MAS004847 RU 25-23

RAPID UPDATE

Rapid Update 802 GranTurismo – Cooling Fan Terminal Inspection

DATE: August 7 2025

Figure 1: Position of the junction node box in the vehicle.

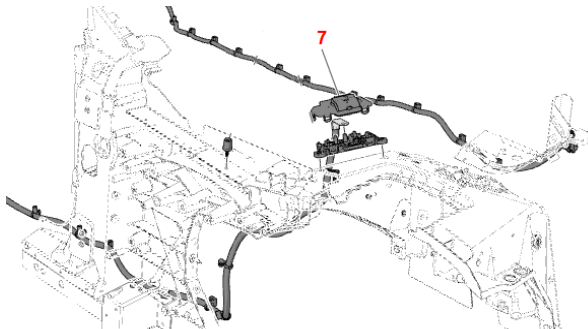
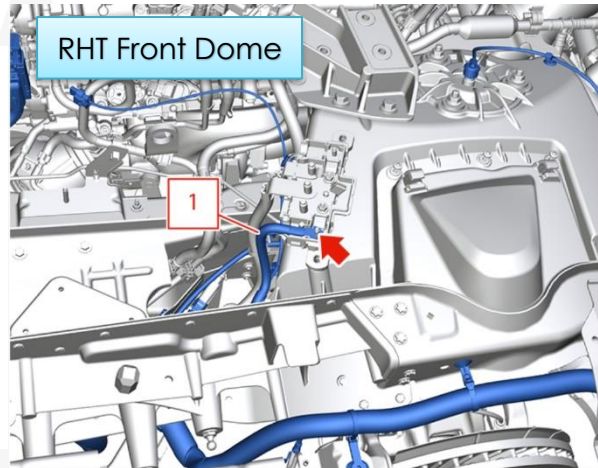
3. Inspect Terminal Orientation

- **Correct Configuration:** Terminal wiring is routed cleanly, seated properly, and clear of adjacent components. No further action is needed. Release the vehicle (**Figure 1**).
- **Adjustment Needed:** Terminal appears to be flipped (**Figure 2**) or in contact with surrounding components.

4. If Adjustment is Needed:

- Disconnect the battery following TechDocs procedure (8.20.001).
- Remove the retaining nut.
- Flip the terminal over so that it is seated properly as per **Figure 1**.
- Install a new nut and torque to specification.
- Reinstall all other components as needed.
